UNITED STATES ENVIRONMENTAL PROTECTION AGENCY  
REGION 2

SUBJECT: Responses to National Remedy Review Board and Contaminated Sediments Technical Advisory Group Recommendations for the Gowanus Canal Superfund Site, Brooklyn, New York

**Figure 1: Total PAH Concentrations in Reference Area Samples and CSO Solids**

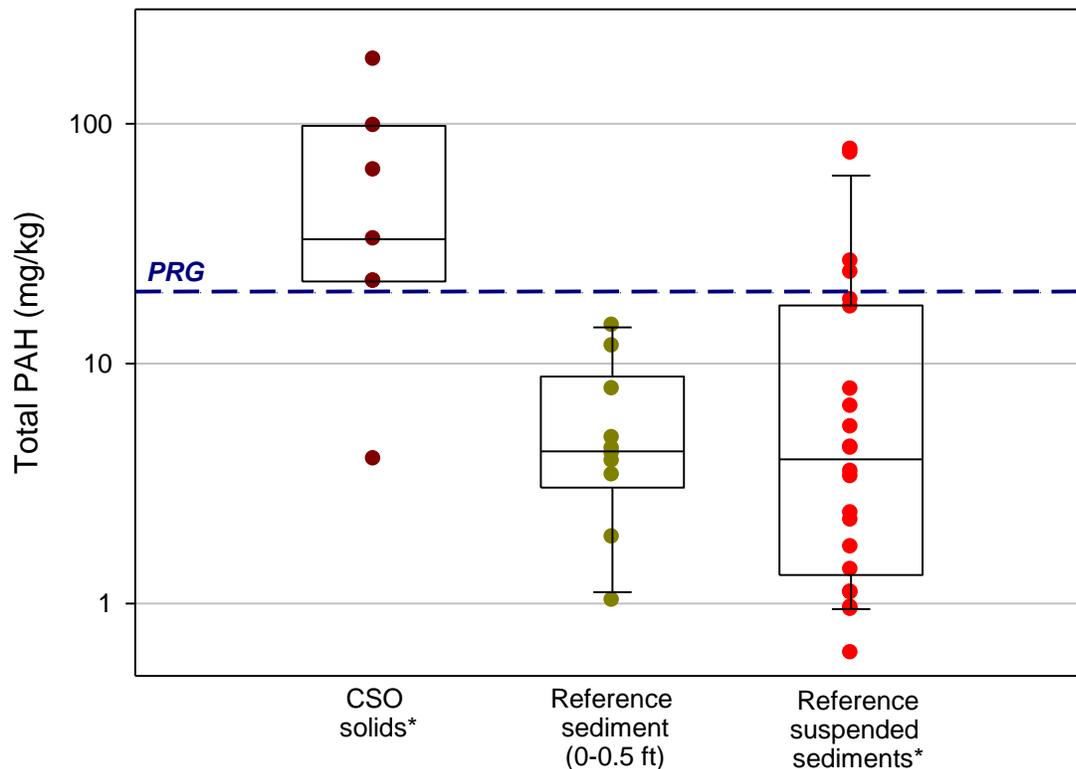
The package provided by the Region to the Boards indicates that current background values are based on samples taken within the Gowanus Bay and Upper New York Bay. The Boards note that the open waters of the Gowanus Bay and Upper New York Bay are substantially different environments from the canal, which is a narrow, man-made waterway. The area surrounding the Gowanus Canal is heavily urbanized with a mixture of residential, commercial and light

industrial land uses. Therefore, it is expected that polycyclic aromatic hydrocarbon (PAH) concentrations in the canal—even without the former manufactured gas plant (MGP) and combined sewer overflow (CSO) contributions—would be higher than the heavily flushed bay areas directly connected to the open ocean. The Boards recommend that the Region explain the basis for the selection of bay area background values and their applicability to the Gowanus Canal environment as compared to determining values that reflect anthropogenic background PAH concentrations endemic to the Gowanus Canal.

The surface sediment data for the reference area samples have been used to represent regional background conditions in Upper New York Bay. Figure 1, below, summarizes total PAH<sup>1</sup>

concentrations in the reference area surface sediment samples, estimated concentrations on suspended sediments in reference area surface water samples, and estimated concentrations on CSO solids from the four outfalls that account for 95 percent of the annual discharge. The median total PAH concentrations in reference area surface sediments and suspended sediments

are similar and are an order of magnitude lower than the median concentration in CSO solids. The PRG of 20 mg/kg falls at the upper end of the range of reference area concentrations. This PRG should be attained if sufficient CSO reductions are achieved. These issues are addressed in more detail in the FS Report Addendum.
